In the Matter of the Application for a Certificate
of Need for the “Power on Midwest”
765kV High Voltage Transmission Line Project

DOCKET NO. ET3, E002/CN-25-117
CN-25-118, CN-25-119, CN-25-120

OVERLAND – CERTIFICATE OF NEED INITIAL COMMENT

Figure 1.8-1: PowerOn Midwest Notice Area

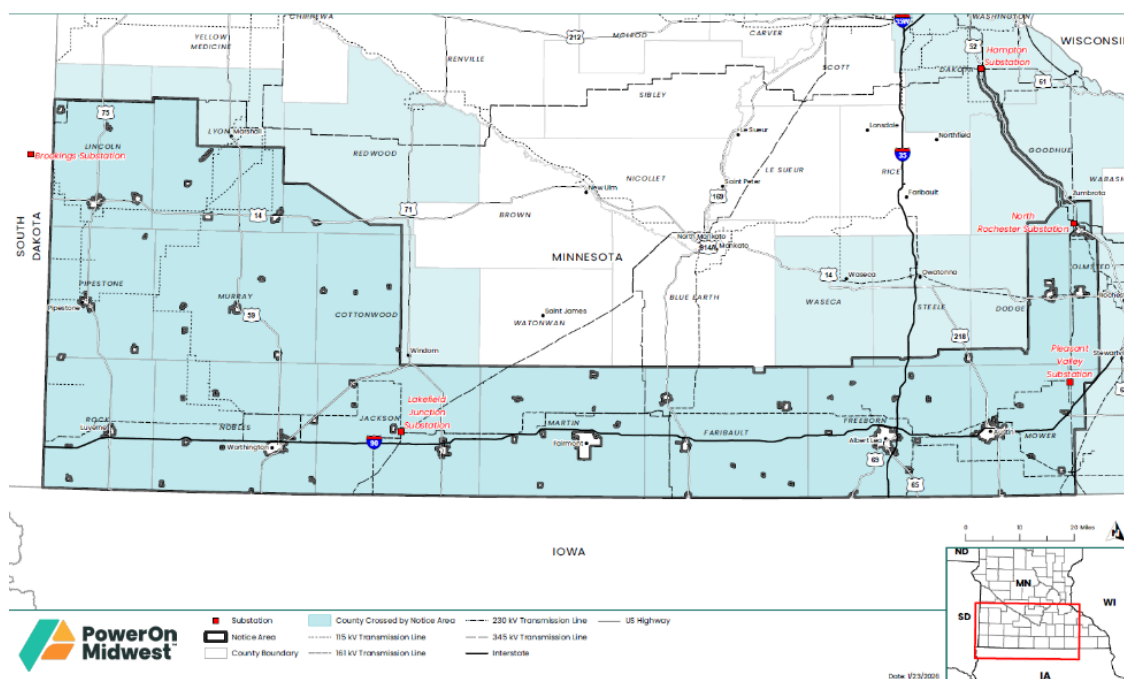
The “Notice Area” map above is insufficient to gain an understanding of the project in relation to the electrical system in Minnesota and the region. The “system” is far more than the “proposed Notice Area” and this limitation is odd when transmission, as we know, is “all connected.”

To comply with Minn. R. 7849.0260 D, the Application must include a map of all high voltage lines over 100kV in Minnesota, South Dakota, Iowa (particularly in light of ITC lines – MVP 3, 4 and 5) and Wisconsin, with visible designation of voltages, substations, of all the regional transmission projects, i.e., all tranche 2.1 projects, and the projects leading up to Tranche 2.1, in permitting process and/or under construction, including SW MN 345kV (EQB Docket 01-1958; CapX 2020; MISO’s MVP 17 project portfolio, Tranche 1, and the MN Energy Connection Lyon Co. to Sherco. A determination of “need” cannot be made without consideration of the broad overview. This map is essential for an understanding of the transmission system and these consolidated projects.

Figure 5.3-1: MISO Region Net Peak Load Expectations Over Time (1994 to 2044)¹³⁸

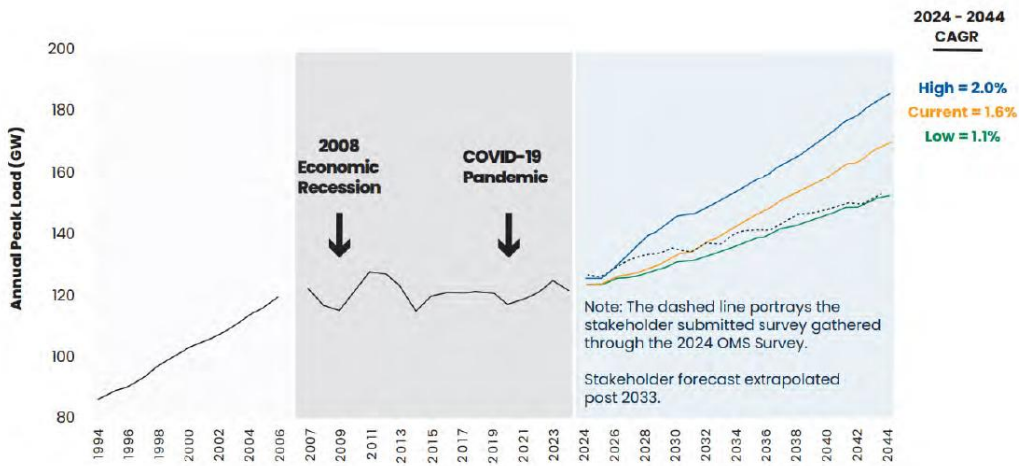
Note the time frames of the increase in demand on Application pages 101-104. Over a 20 year period, the increase predicted is not extreme.

A look at MISO's "Long-Term Load Forecast" from December 2024⁸ also uses this chart above to depict "Net Peak Load Expectations Over Time (1994-2044)."⁹ This report identifies "five" key drivers, though it lists six, most of which are not credible:
